Memo.

Ecology Technical Report to inform the S42a report for the Taumatotara Wind Farm	To: Chris Dawson BBO
	From: Dr Leigh Bull
	Project No.: BG2301
Date: 12 October 2023

Technical Review of the Ecological Effects Assessment for the proposed variation

Appendix 1 – Ecological Monitoring and SNA map

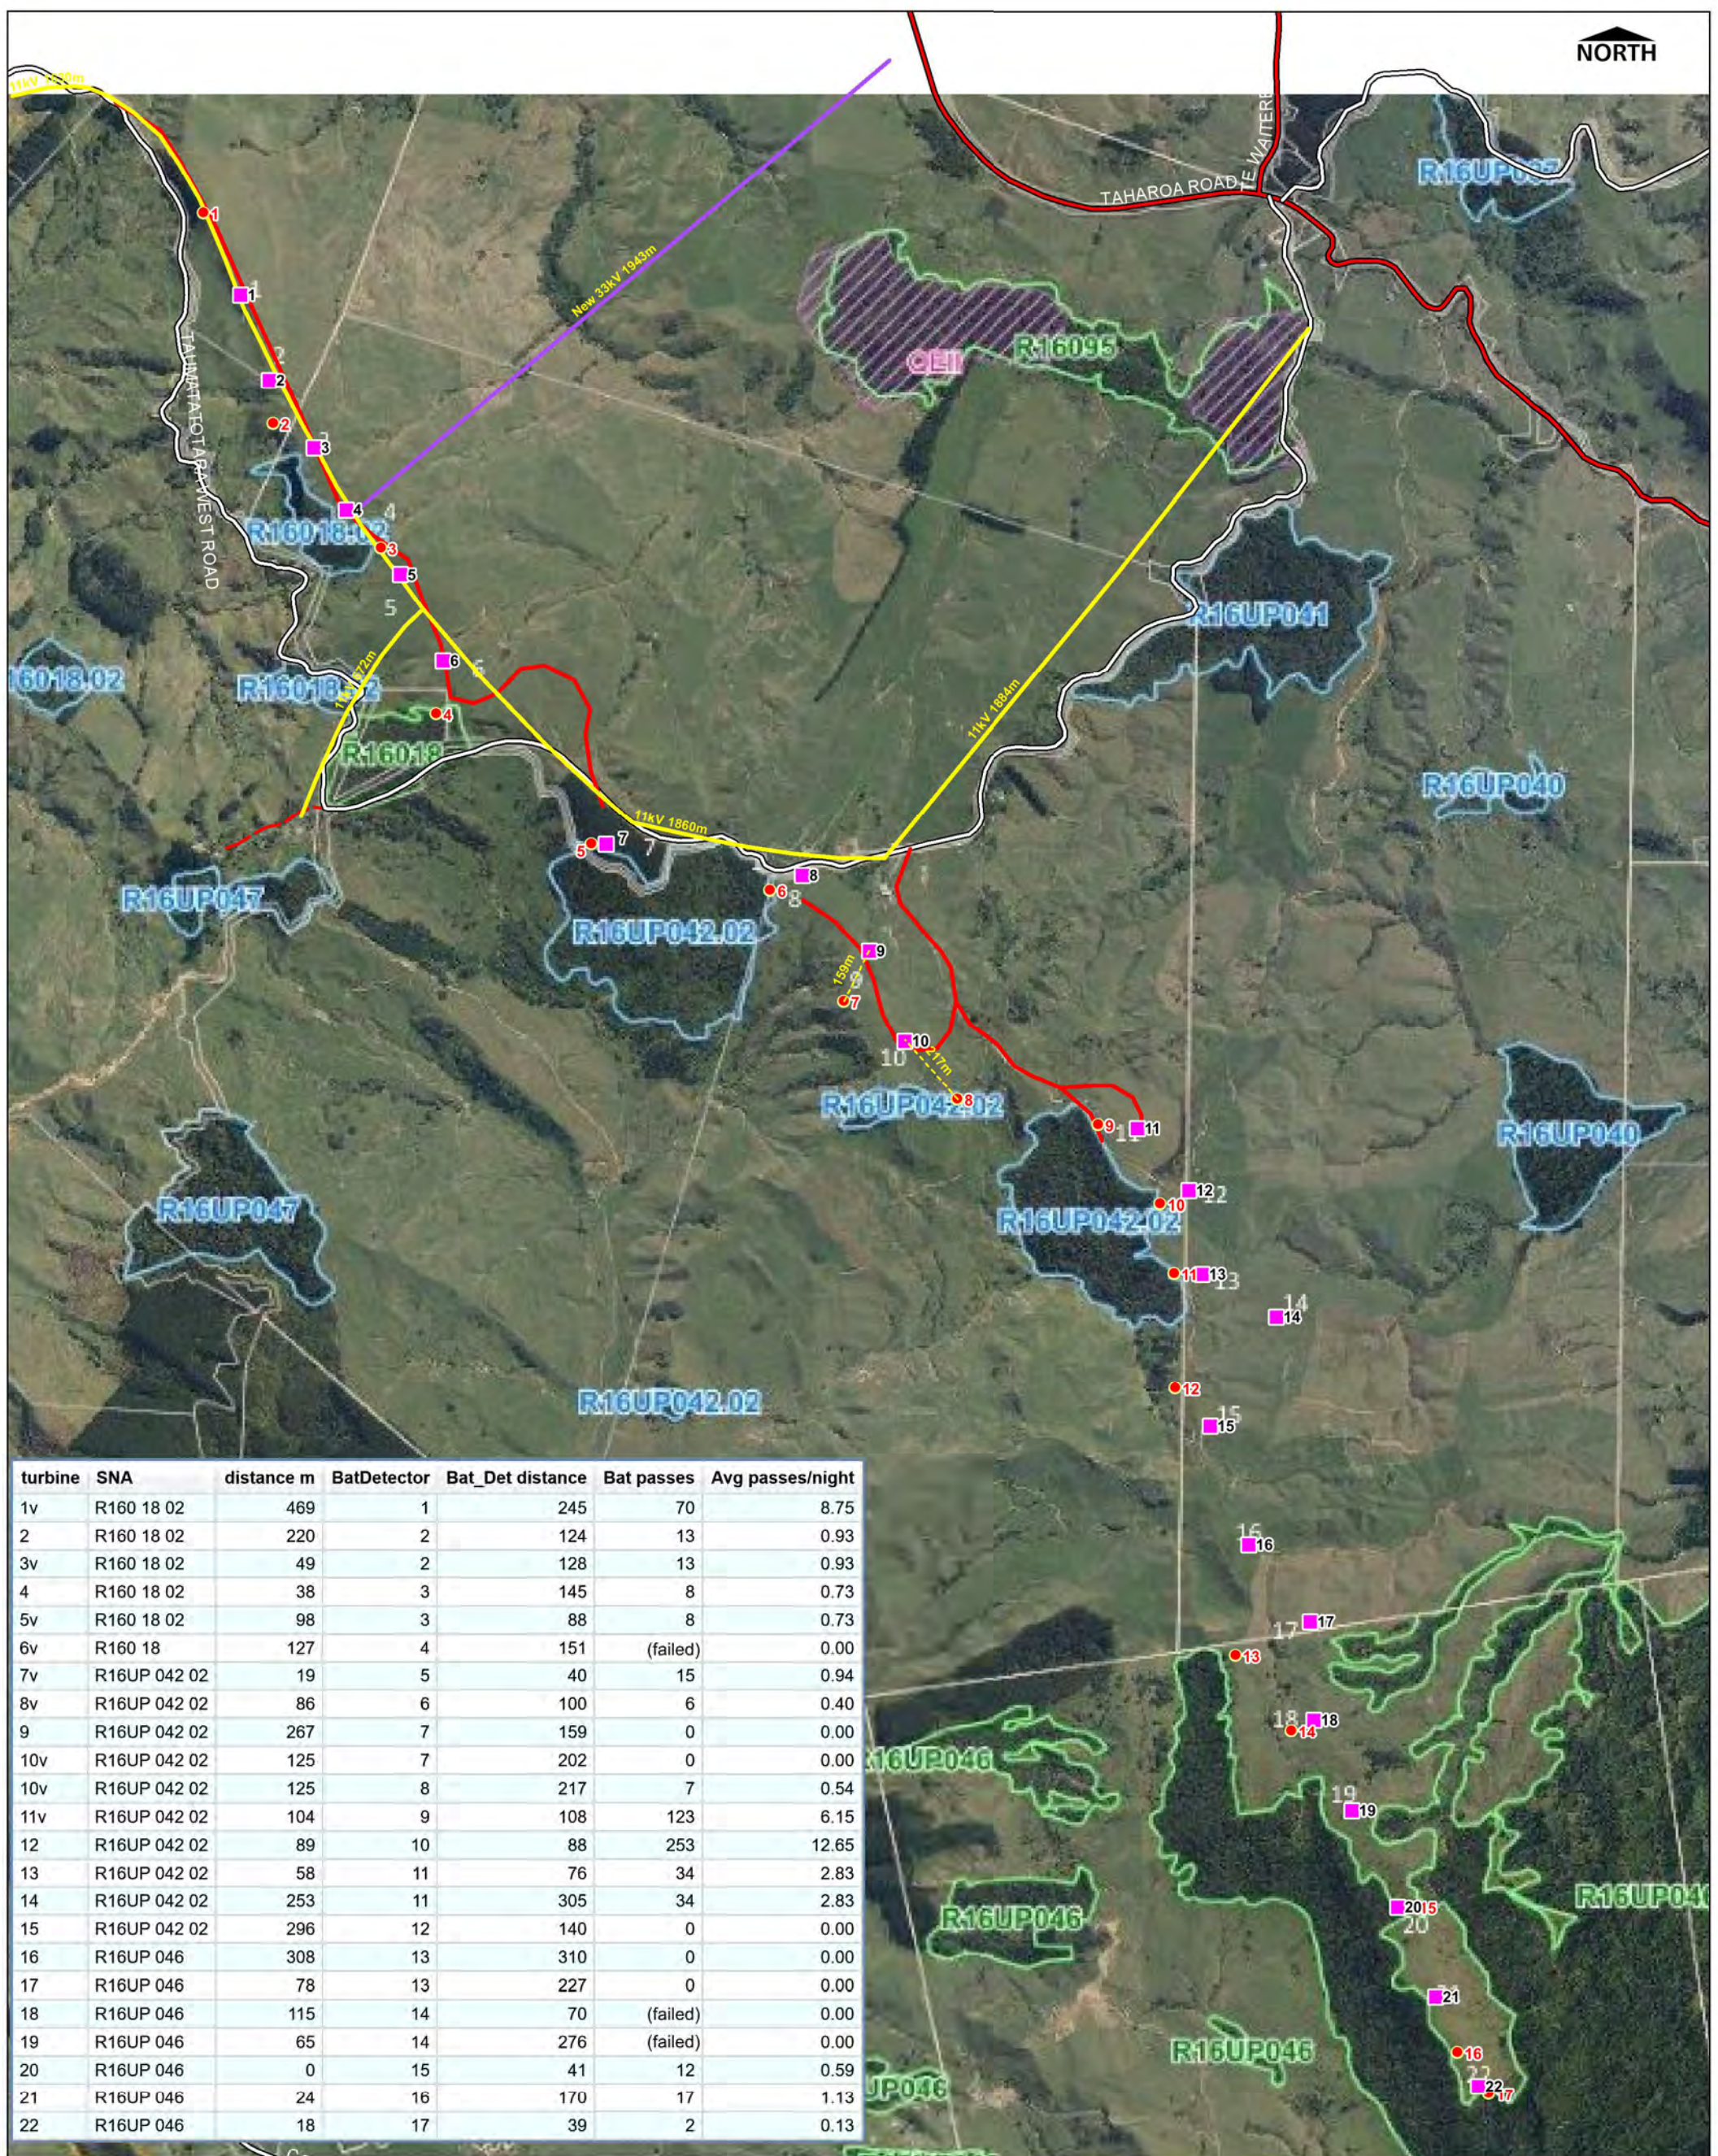
34. However, given no further details were provided at that stage, a request was made to the Applicant for a map showing the locations of the bat survey sites, turbine locations and distances of turbines from the Significant Natural Areas (SNAs) in order to better understand the proposed changes in an ecological context; this map was provided on 29 September 2023 and is included in Appendix 1 of this report. Information in the table on that map is replicated below and ordered based on highest to lowest average number of bat passes. The turbines which are proposed to be removed are identified in red text, and do not include the turbines at which the highest levels of bat activity were recorded (those being turbines 1, 11 and 7).
